In the matter of an application by Ryman Healthcare Ltd
For resource consent to establish and operate a comprehensive retirement village and associated activities at 7-37 Ngataringa Road and 1-88 Wakakura Crescent, Devonport

**Statement of Evidence of Richard Leonard Cheyne Reid for
Ngataringa Bay Action Group**

28 November 2016

VP04 Jim Titchener Parade

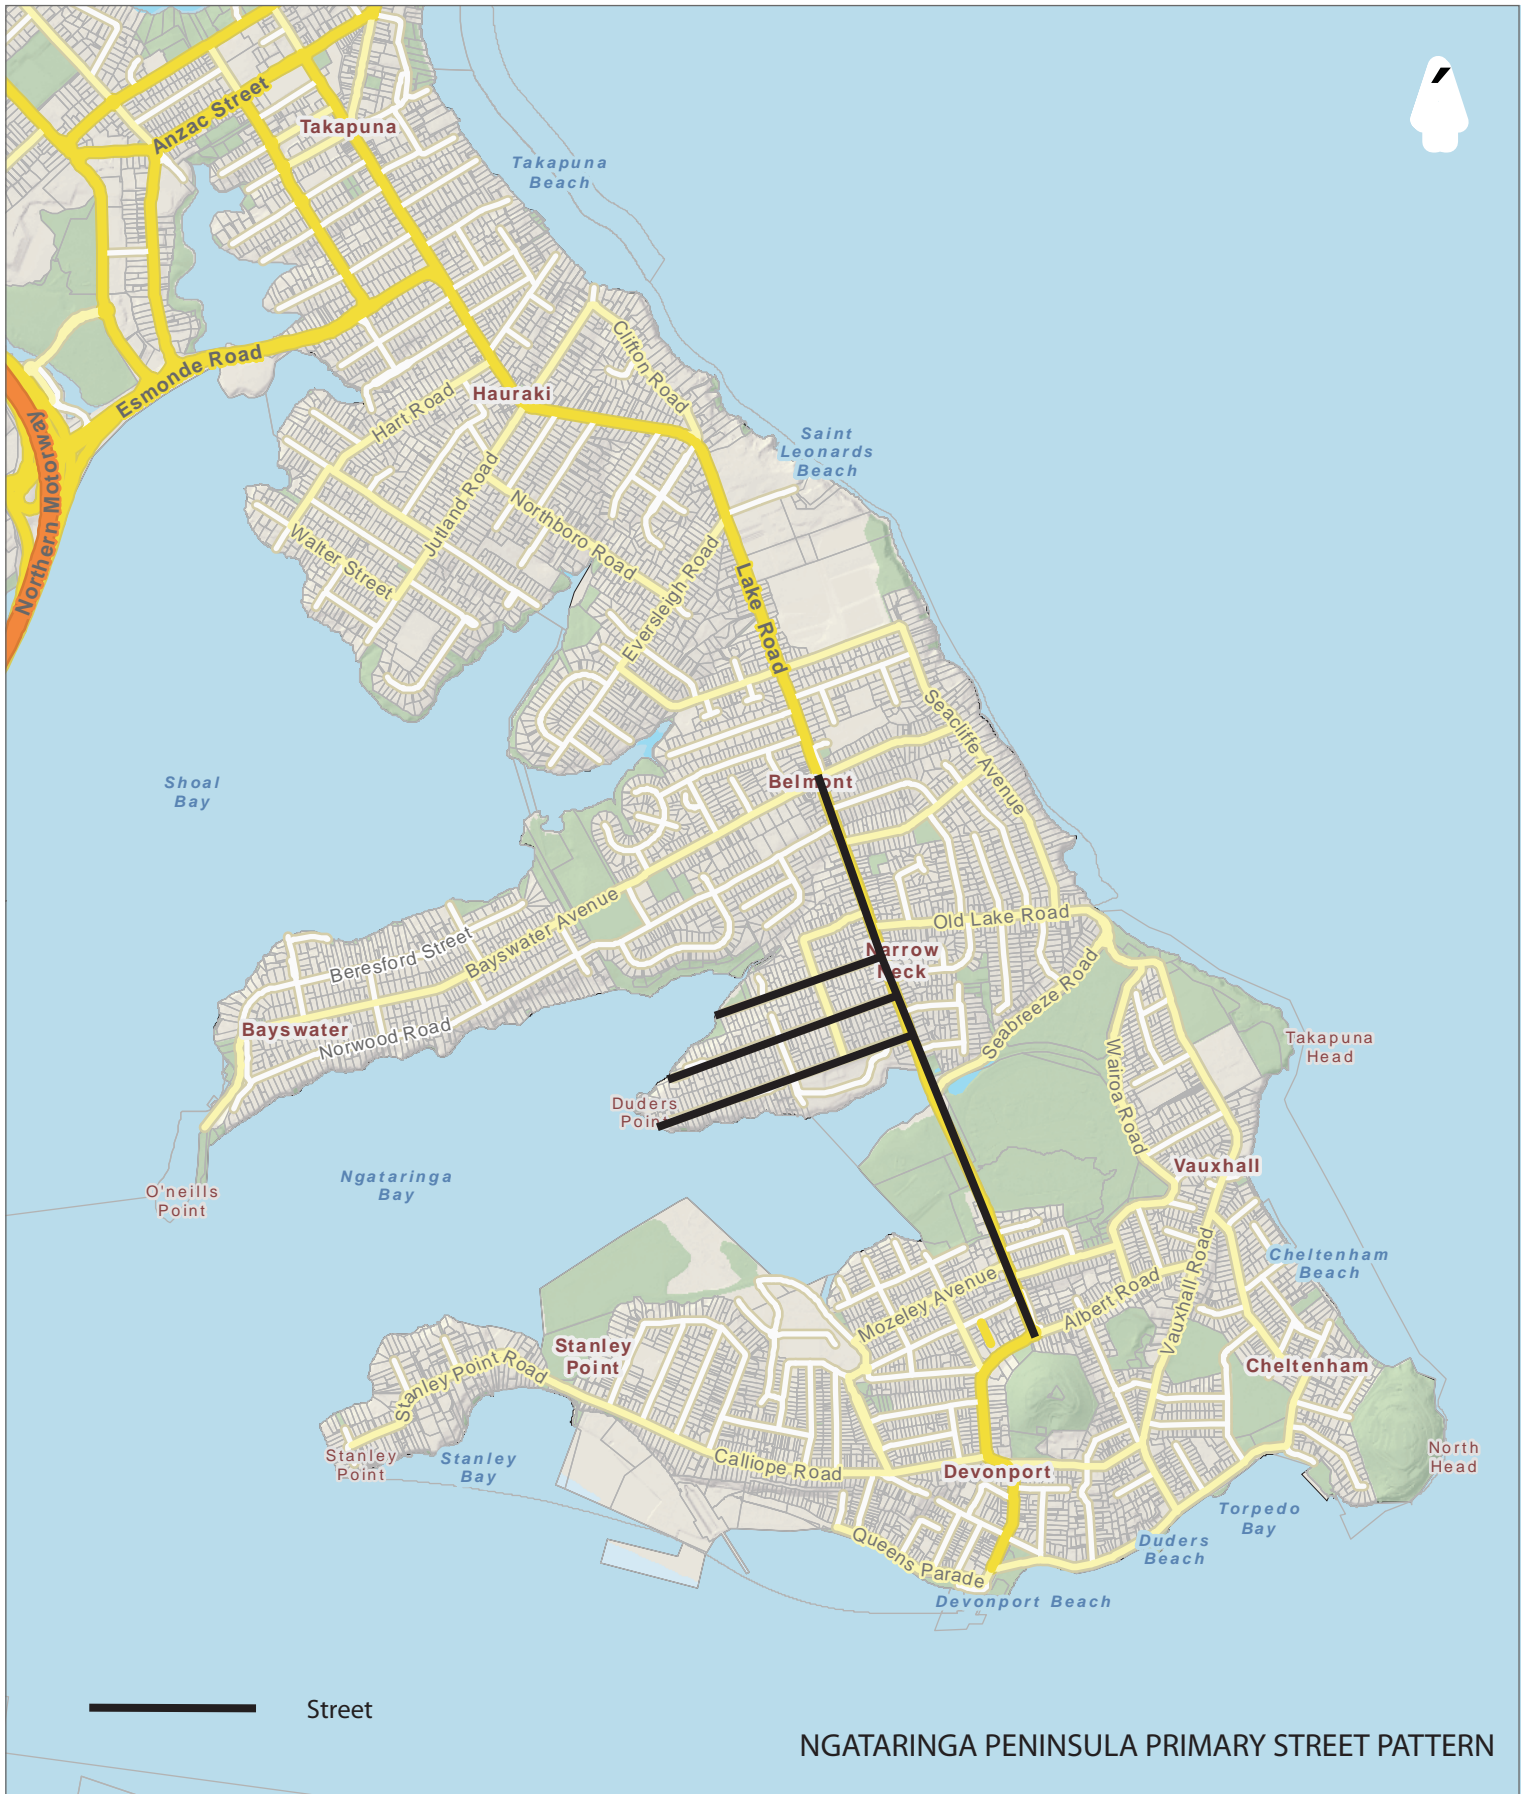
- 3.6.8 I have prepared photomontages of the village seen from the south-west using the V04 photomontage from Jim Titchener Parade by the applicant as the base model. My analysis finds:

- i) the adverse effects of B03 are significantly reduced when the fifth storey is removed (Fig. 04)
 - ii) the adverse effects of B02 are reduced when the sixth storey is removed but adverse effects still remain (Fig. 05). The difference in ground level, building height and vertical emphasis of B03/B02 versus B01/B05 is still too contrasting. There is only a distant relationship between B02 and B01. The overall composition is skewed or weighted too heavily on B02 and B03's prominence at the expense of the rest of the village. The village appears divided into two halves instead of forming and presenting a cohesive whole.

3.6.9 I have also examined whether removing the fifth storey from B02 provides the additional reduction in effects needed. I consider it does. Although removing the fifth storey may appear to create a consistent building height across the development's southern elevation, the changing ground levels will mean there is sufficient variation in building profile to achieve the mixture of building heights sought in the relevant precinct policy.

Study #2 of Applicant's Proposal -
B02 reduced by two storeys and
B03 reduced by one storey

Fig. 10

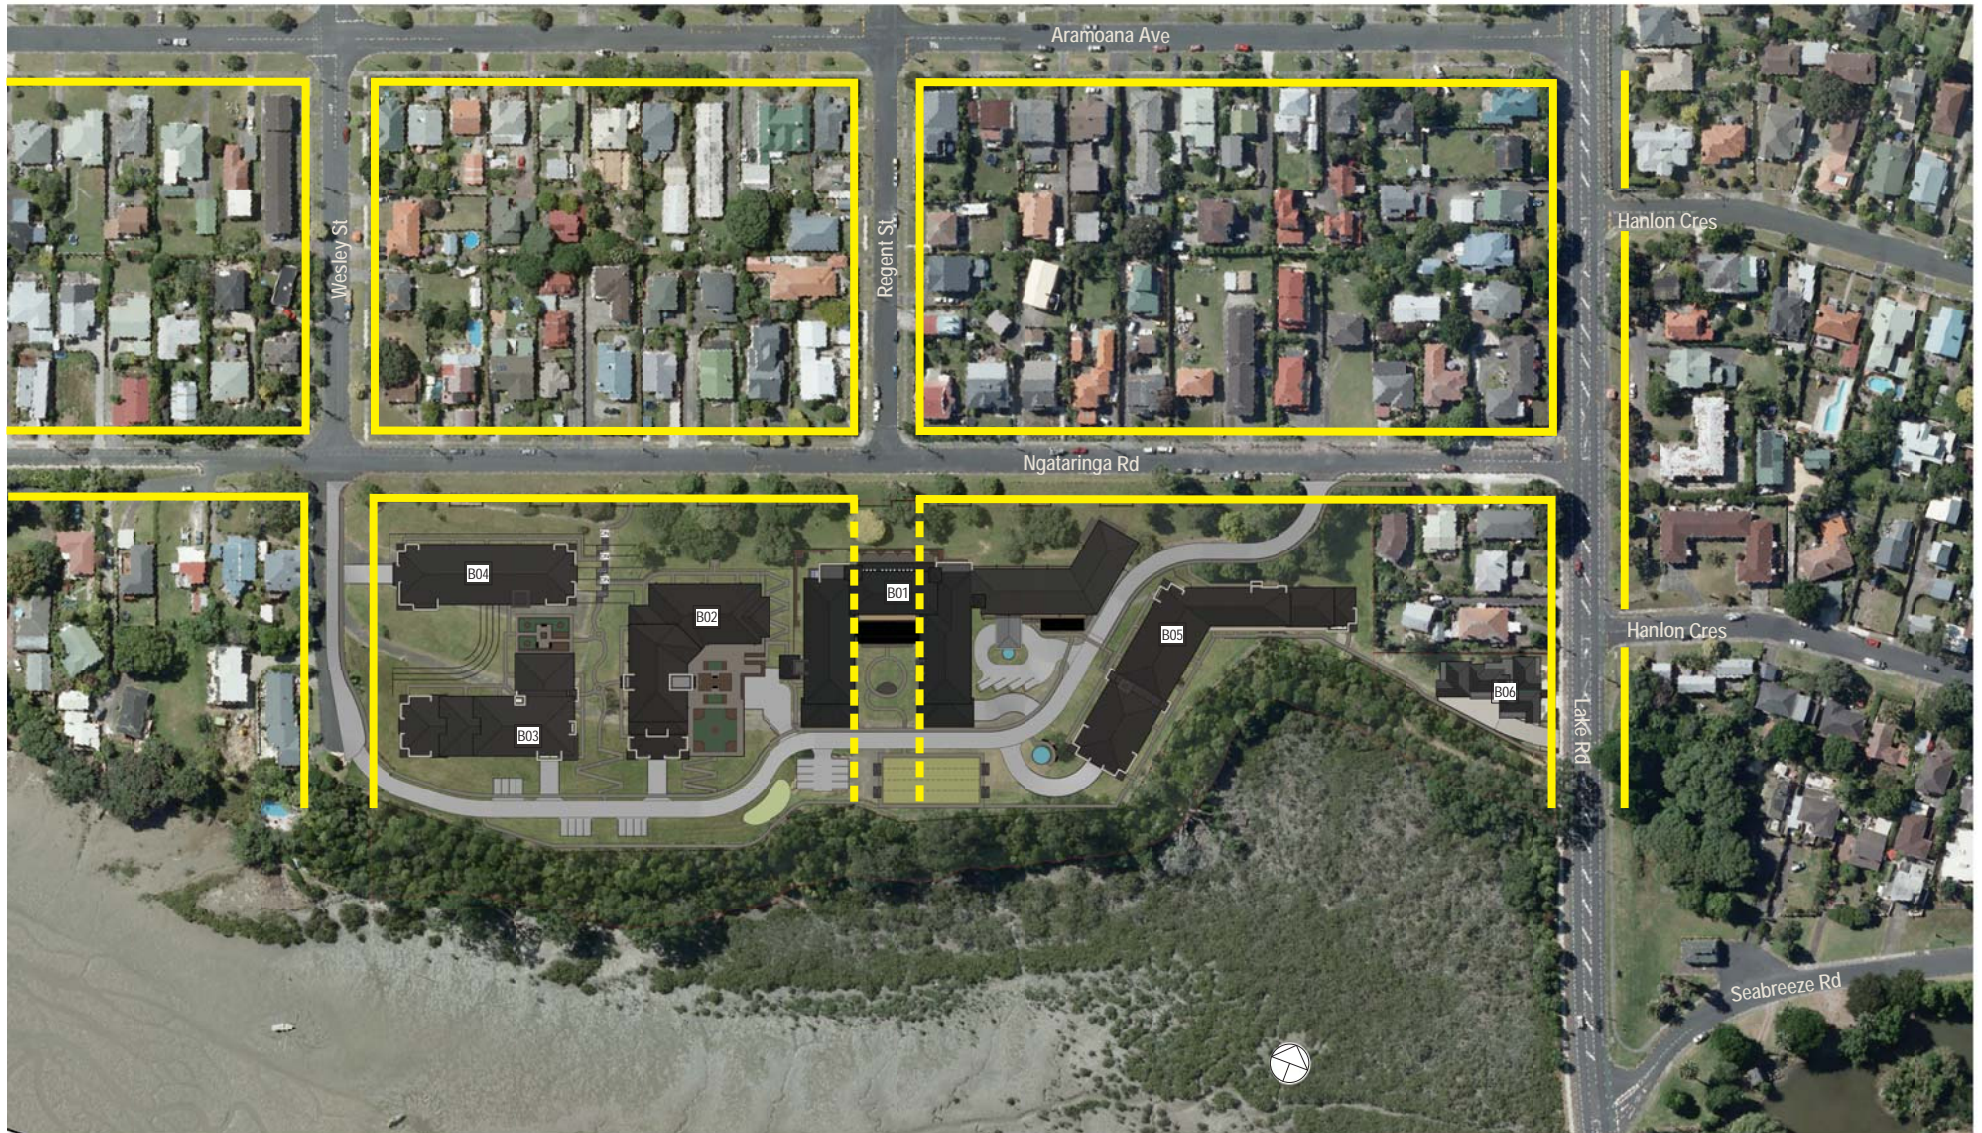
- 5.2.6 Great cities can sometimes show us something of our future. San Francisco has a similar street pattern and open space structure to 19th century Auckland peninsula settlements. San Francisco has protected these underlying structural elements through successive waves of development and intensification. The streets are controlled and work like viewshafts. Their ridgeline to harbour trajectory have become a defining feature of the city (Fig. 10).

Fig. 12

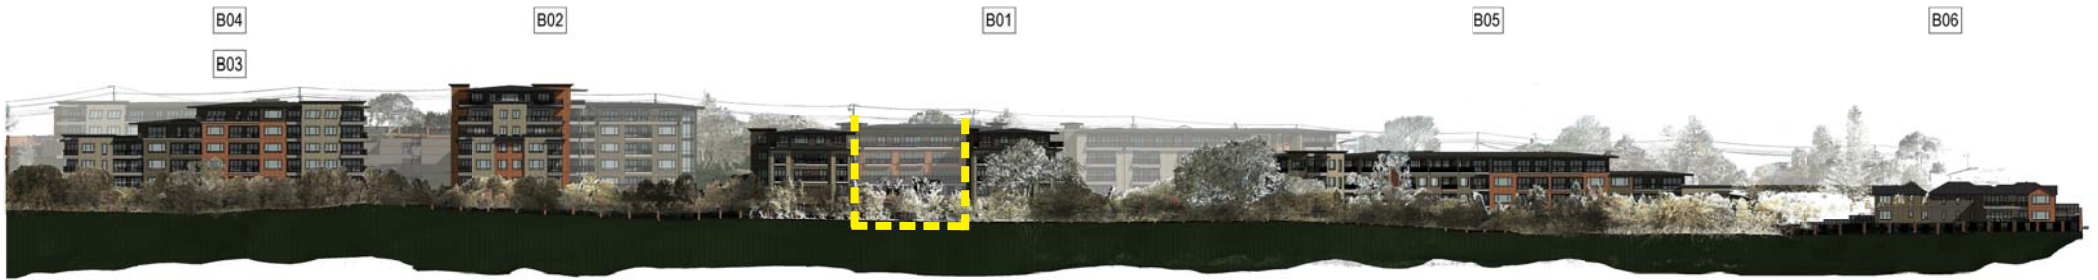
- 5.4.1 I have prepared a plan which accommodates the Regent Street viewshaft (Fig.13).
- 5.4.2 Coincidentally or not, the southern wings of B01 are closely aligned with Regent Street's road reserve boundaries (Fig. 12). B01's courtyard space is therefore already dimensioned to accommodate the viewshaft through it. The building's wings can form the viewshaft's edges, with the main body of B01 running westwards. There is sufficient space on the site for a reconfigured B01 to accommodate its internal functions and congregate around a new courtyard space. This courtyard space could open up more to the west to improve solar access, reduce shading and reintroduce an east-west pedestrian route through the site.

Fig.13

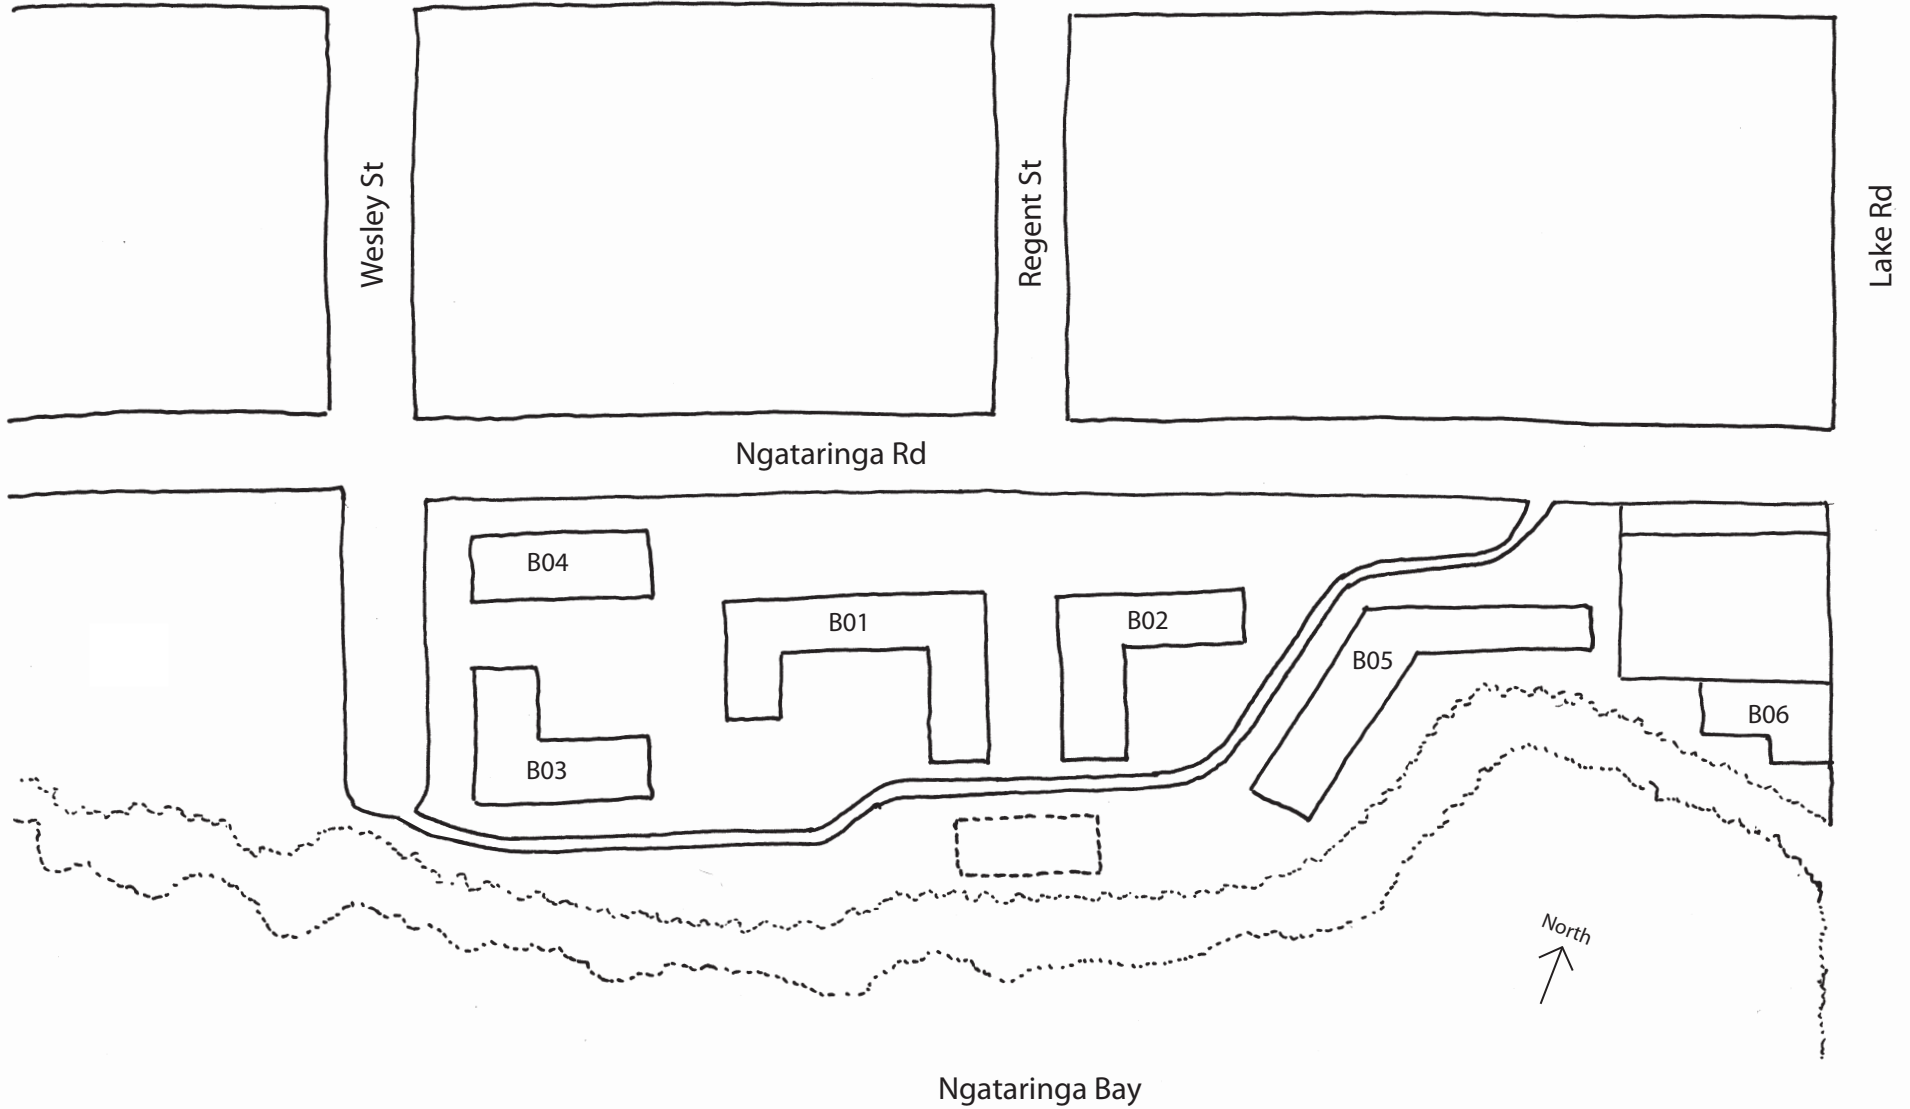
- 5.3.2 With limited openings penetrating its 330 metre length, the proposal creates a visual wall of buildings lining the street.
- 5.3.3 I recommend Regent Street be continued through the site as a viewshaft. This will break up the wall of buildings lining Ngataranga Road, protect Regent Street and Ngataranga Road's visual connection with the harbour and integrate the village with the underlying urban structure of the peninsula (Fig. 11).
